**ADDENDUM NO. 2**

**CITY OF GATESVILLE**

**CID 01-STILLHOUSE BRANCH WASTEWATER TREATMENT FACILITY  
IMPROVEMENTS**

**PROJECT NO.: 2-01590 | TWDB CWSRF NO. 73776**

5-8-23	DATE	MICHAEL CLOUGH
PM	DESIGNED	J. JENKINS
	DESIGNED	M. CLOUGH
	DRAFTED	TFG, PA
	CHECKED	J. JENKINS
	PROJECT NO.	2-01590
	DRAWING NO.	C-04

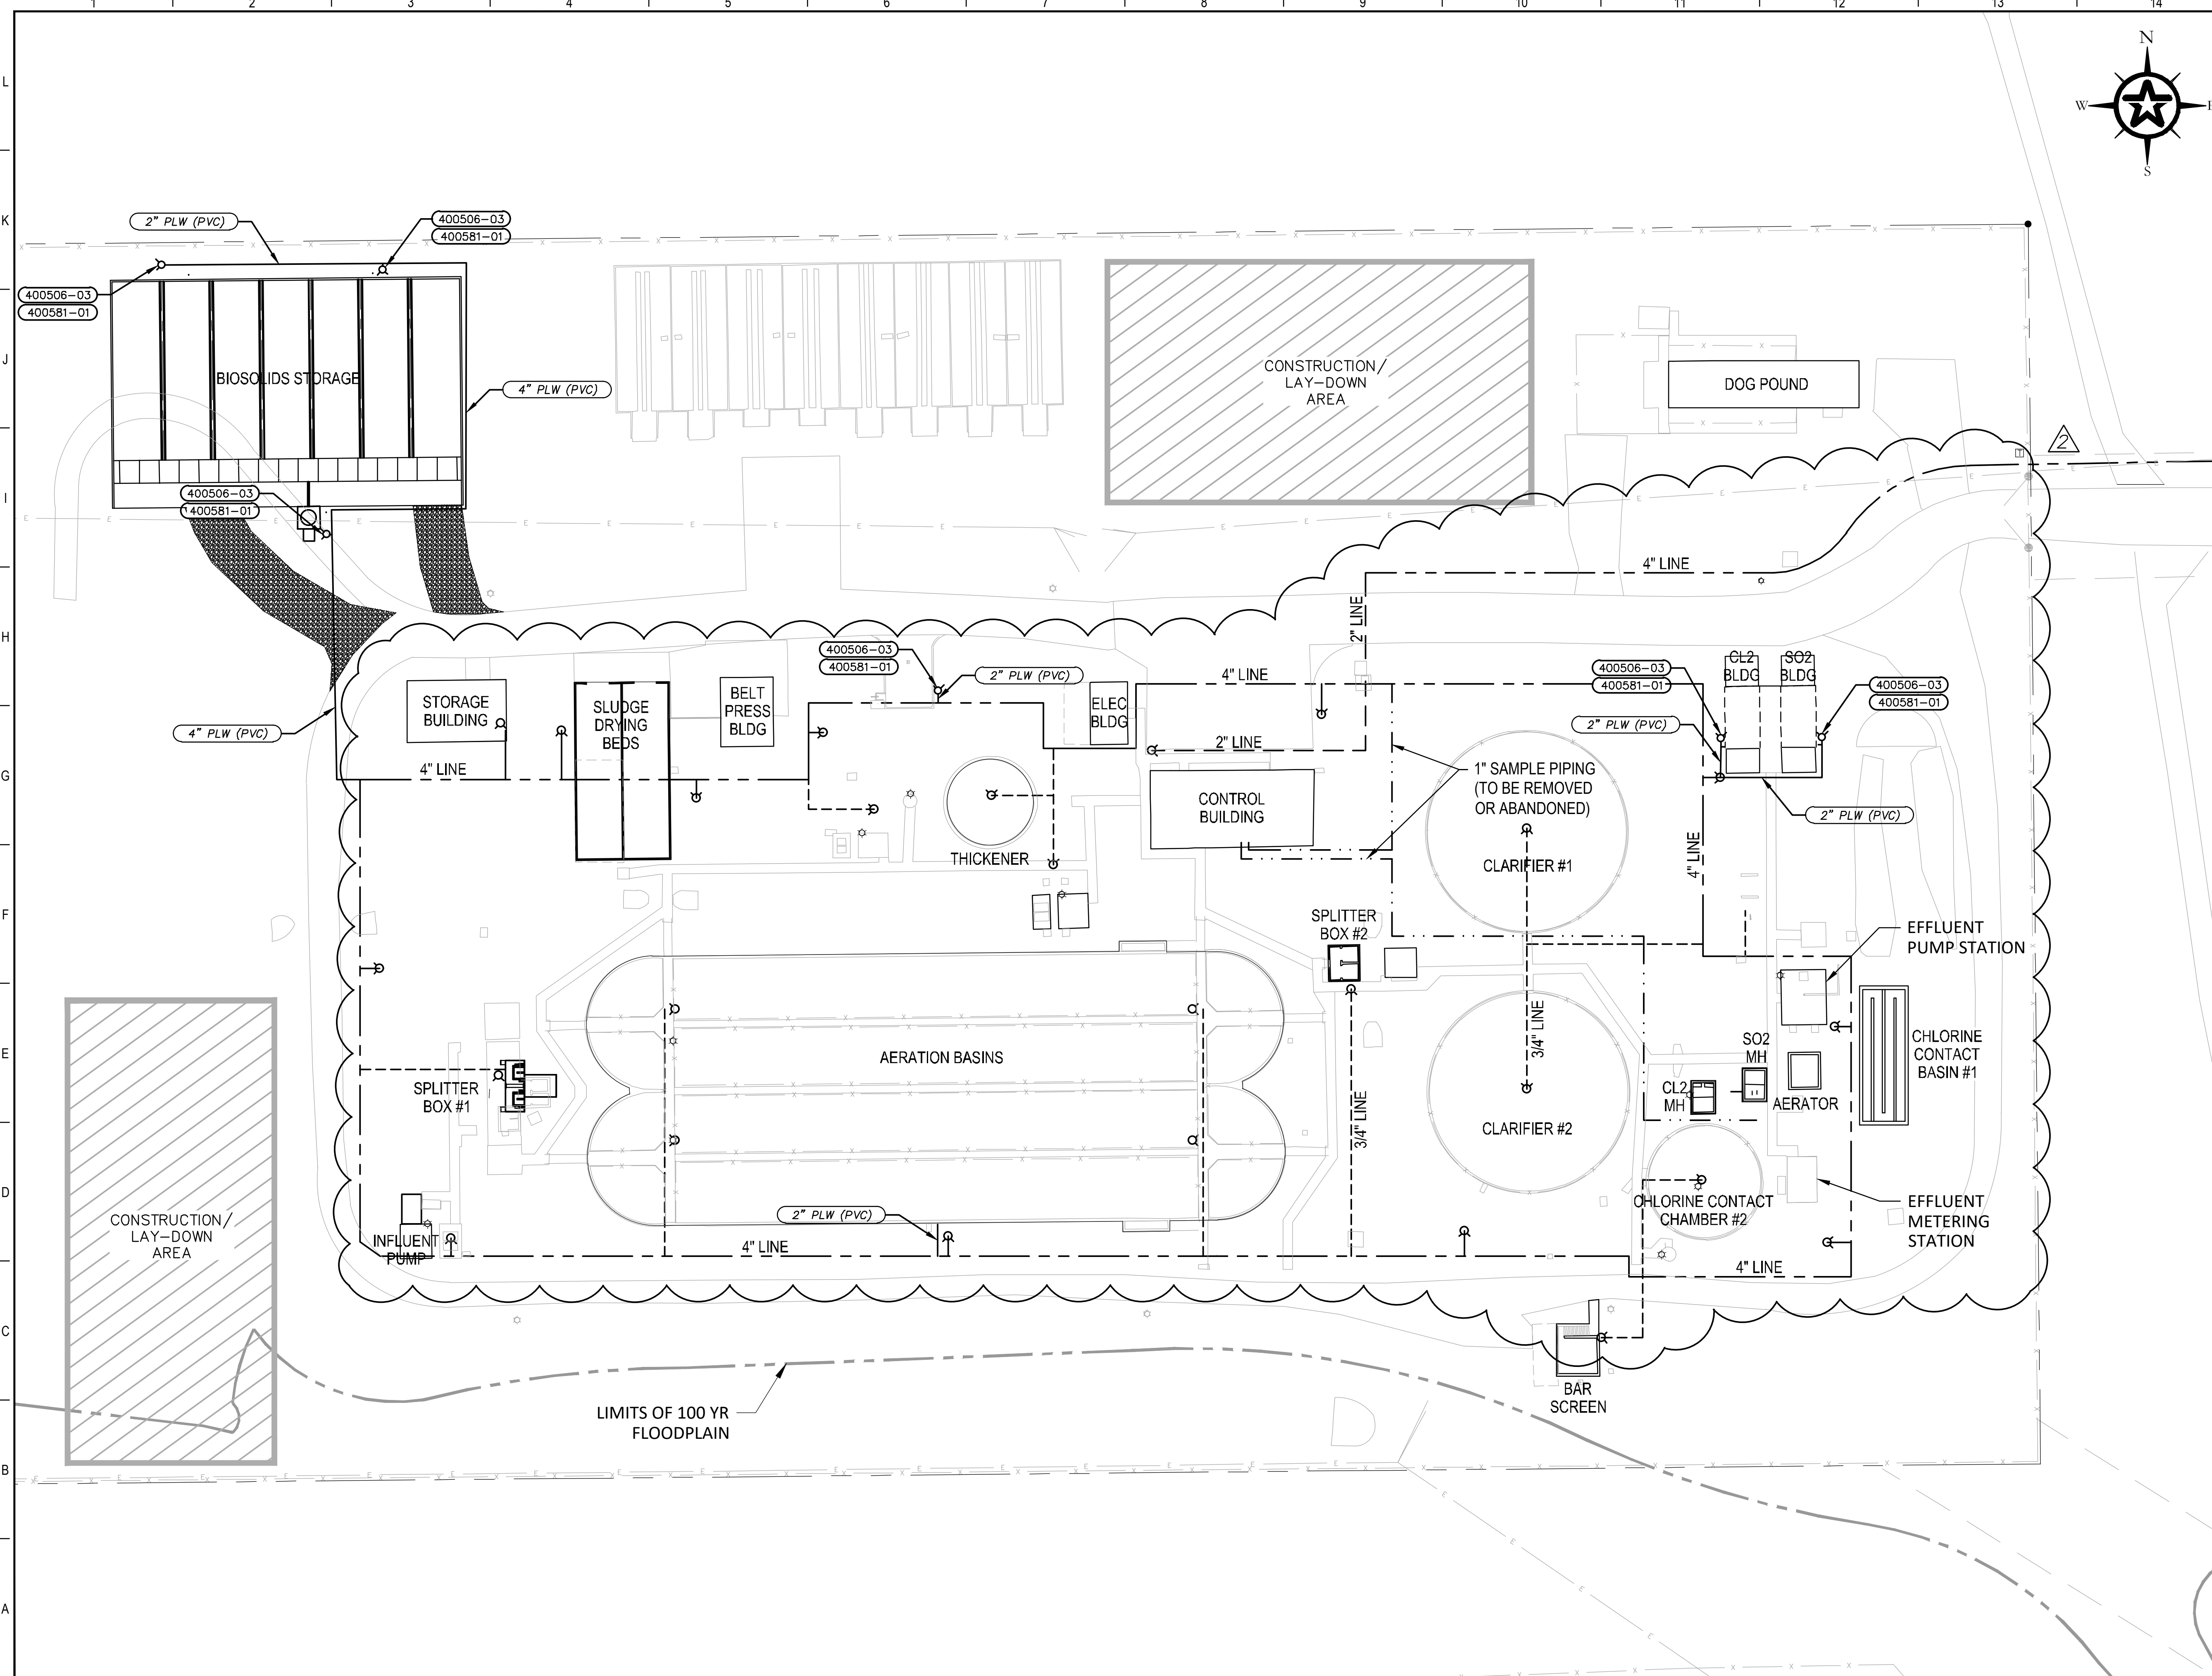
- 1) Drawings
  - a. Sheet C-04  
REVISE to include existing line size.
  - b. Sheet C-08  
DELETE blank revision notation.
  - c. Sheets M-04 and M-05  
REVISE valve schedule to include specification references.
